## SURVEY DATA

Year Completed	Intersection ID	Survey Street	Cross Street	
TBD	1448	10th St	S B St	
Orientation & ID #	Ramp Type	Existing Access Barrier and Proposed Solution	Codes / Mitigation Info	Measurements

4357 Ramp Slope

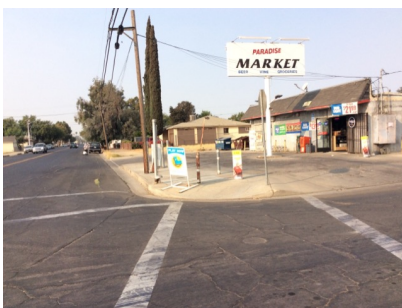
- *As-Built Description:*  
Running slope of existing perpendicular curb ramp is less than 5% or greater than 8.3%.
- *As-is* **9.2%**
- *Proposed Solution:*  
Demolish existing and provide new, perpendicular curb ramp, including detectable warning surfaces, and top and bottom landings as required.

CBC 2019 **11B-406.2.1**  
CBC 2007 **1127B.5.3**  
ADAAG **4.7.2; 4.8.2**  
ADA-2010 **405.2**  
PROWAG **R304.2.2**

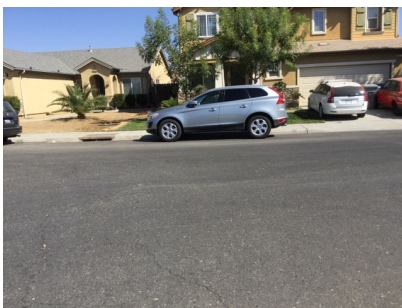
Provide a parallel curb ramp, including detectable warning surfaces, and top and bottom landings as required.

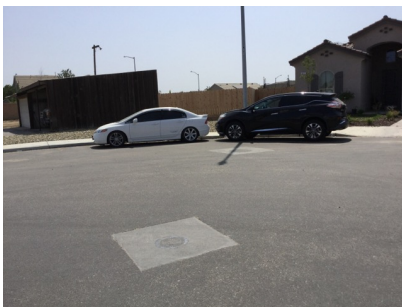
Provide a parallel curb ramp, including detectable warning surfaces, and top and bottom landings as required.

**1261 Pedestrian Access Route**

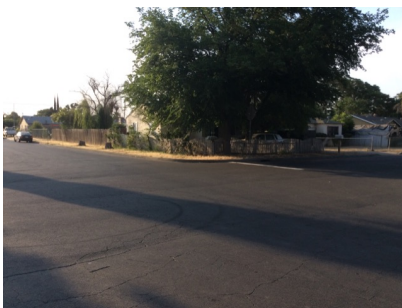
- *As-Built Description:*  
No curb, curb ramp, or sidewalk provided. Pedestrian access route is along the vehicular lane and is not separated by a curb or other cane detectable warning.
- *Proposed Solution:*  
When curb or sidewalk is installed along either street, provide accessible curb ramp.

3534 Access Route

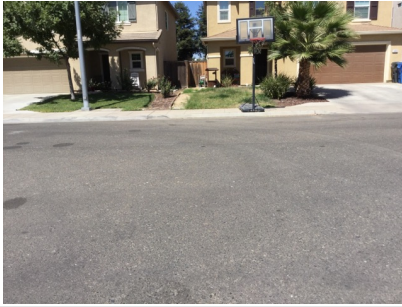
- *As-Built Description:*  
Curb ramp or blended transition not provided where a pedestrian access route crosses a curb.
- *Proposed Solution:*  
Provide a parallel curb ramp, including detectable warning surfaces, and top and bottom landings as required.
